NextEra Energy Transmission West and Pacific Gas and Electric Company

Estrella Substation and Paso Robles Reinforcement Project

Proponent's Environmental Assessment (A.17-01-023)

Response to Deficiency List No. 4

Exhibit G (14)a: New Paso Robles 1105 Underground Express Feeders to Prospect Avenue

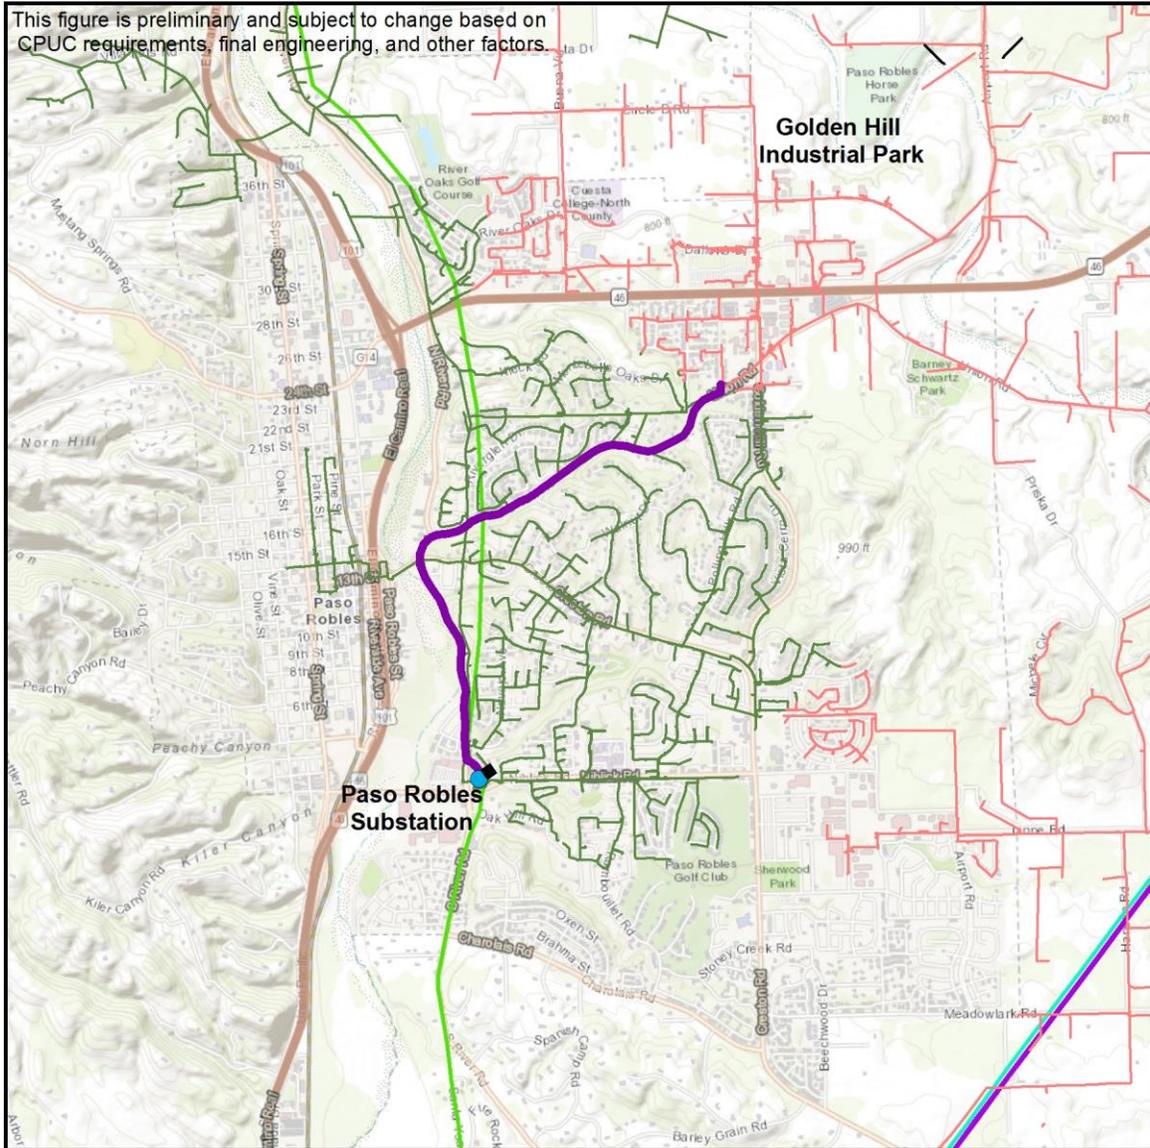
Have NEET West or PG&E evaluated battery storage as a potential alternative to the proposed Estrella Substation or certain components of the substation? If so, please provide a full update on the analysis performed and results.

Avenue. This battery storage would have the potential to delay the installation of Estrella Substation distribution components, from a capacity perspective, for approximately two years. However, as explained further below, it would: (1) provide a solution that is only temporary, (2) limit, rather than improve, operational flexibility, and (3) not increase the circuit reliability of the Paso Robles DPA.
